SAN MIGUEL ELECTRIC CO-OPERATIVE, INC.
SAN MIGUEL LIGNITE MINE
B-NORTH HAUL ROAD
TYPICAL DETAILS

SAN MIGUEL ELECTRIC COOPERATIVE, INC.
PLAN AND PROFILE
AND SECTION B-NORTH
HAUL ROAD

We have a drop structure off our haul road that allows water to drain off the permit boundary towards La Parita Creek. Lately, the runoff has contained excessive sediment and we have had a couple of occurrences where sediment has left the permit boundary. To remedy this situation, we are proposing to construct a new haul road pond where the drop structure is located to improve the capture of sediment.

BN-2 Drop Structure Action Plan

TYPICAL
DROP STRUCTURE
PLAN VIEW
SCALE: 1" = 10'

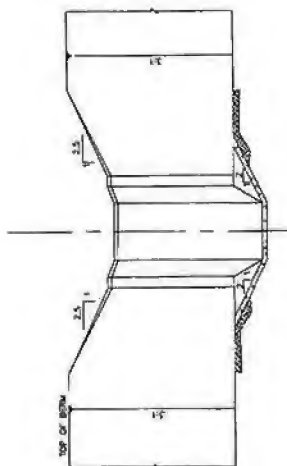
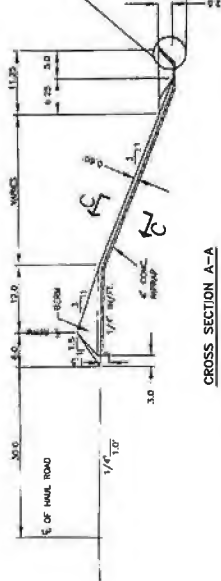
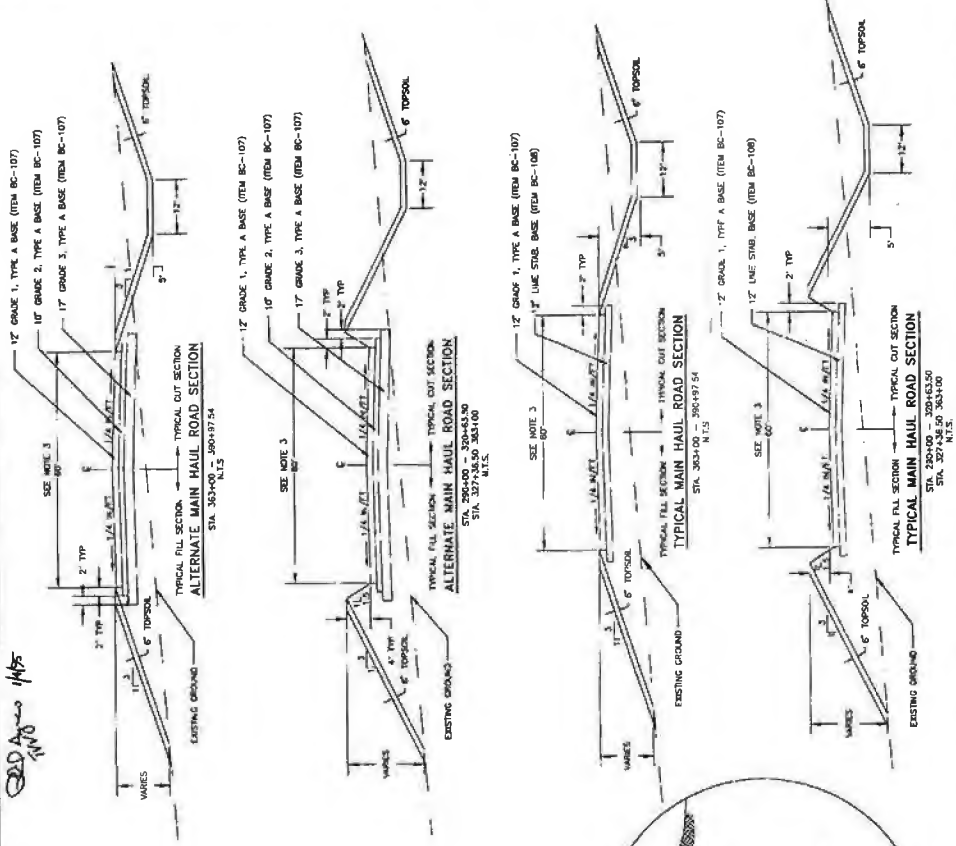
The design plans that he sent me were from 1993, I have attached them to this email and these are the same ones that you and I looked at in your office last week. One set shows plans for a typical drop structure on the B-North Haul Road and the other is the plan and profile of the B-North haul road, the B-North haul road plan and profile does not show any drop structure between Pond J and the Bridge going over LaParita creek.

I've looked both documents over and have yet to find any mention of the where the drop structure is to be located. That is what I'm having trouble with, shouldn't the locations of any drop structures be shown on the plan and profile drawing or was this drop structure just built because they had a problem with runoff from the B-North Haul road. As you and I discussed it's a bad place for a drop structure without room for a supporting structure to hold the sediment.

So here's my question to you, I have no doubt that the drop structures installed were designed for somewhere on the B-North Haul road, but does a drop structures location on a primary road have to be shown on a map or can the mining company just put one in where they see the need as long as it is built to a typical design, or is there an

approval letter somewhere granting them permission to install the drop structure where it is installed?

I have attached copies of the road design and a typical design for drop structures associated with the road. The road and associated structures were approved as a part of the SMLM III permit renewal/revision.

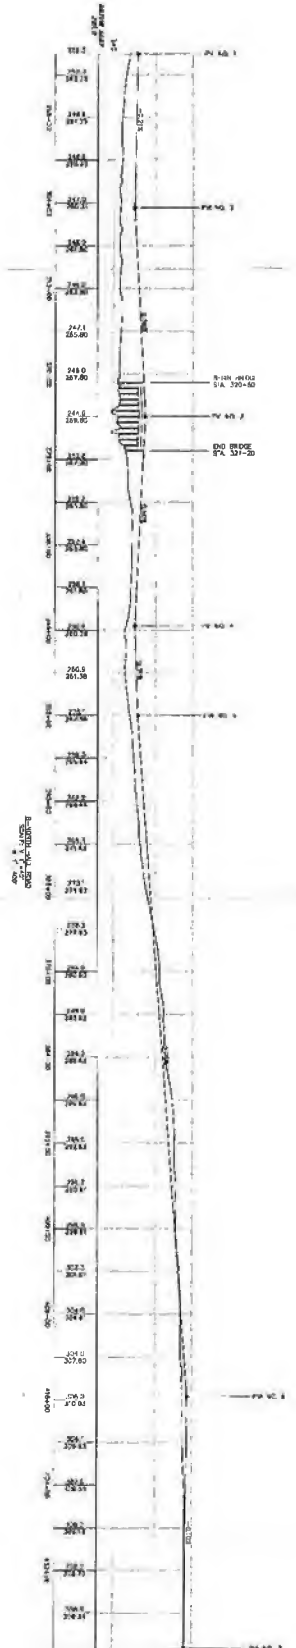
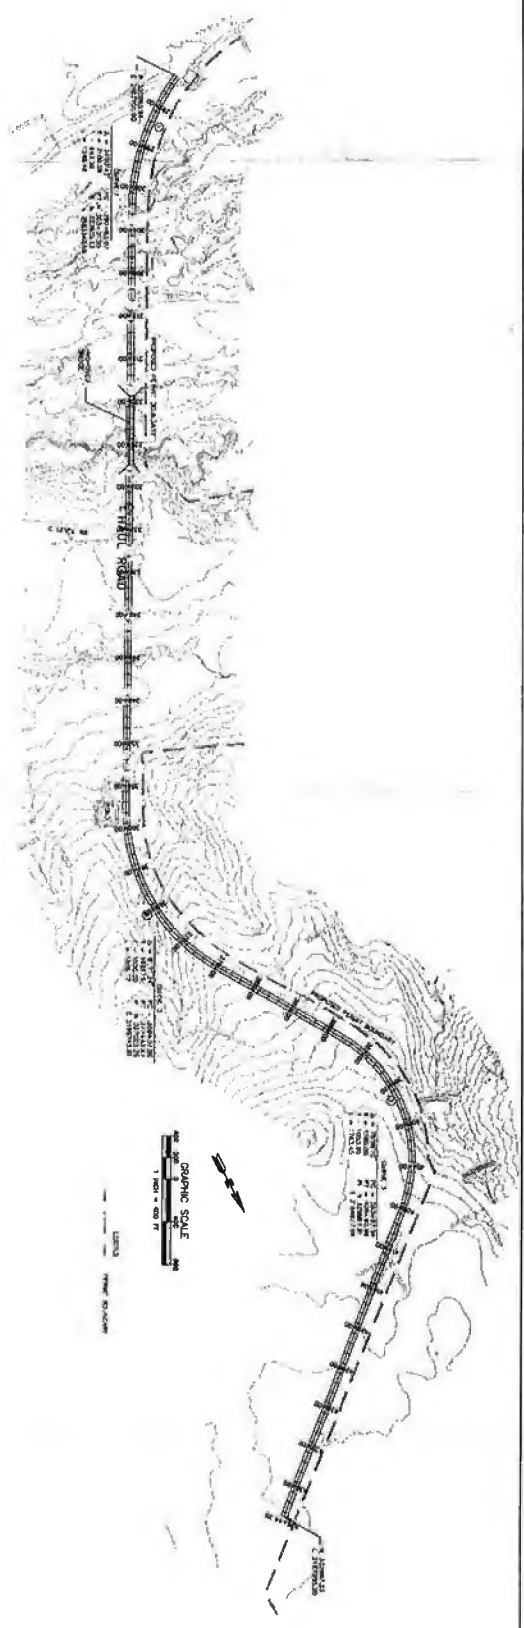
Robin, attached is the B-North Haul Road Plan and Profile showing the drop structure and location along the haul road. Note that the drop structure shown on the right side of the haul road (looking north) was not installed. I will also send you a scanned copy of the approval letter approving the entire package that included these particular items.
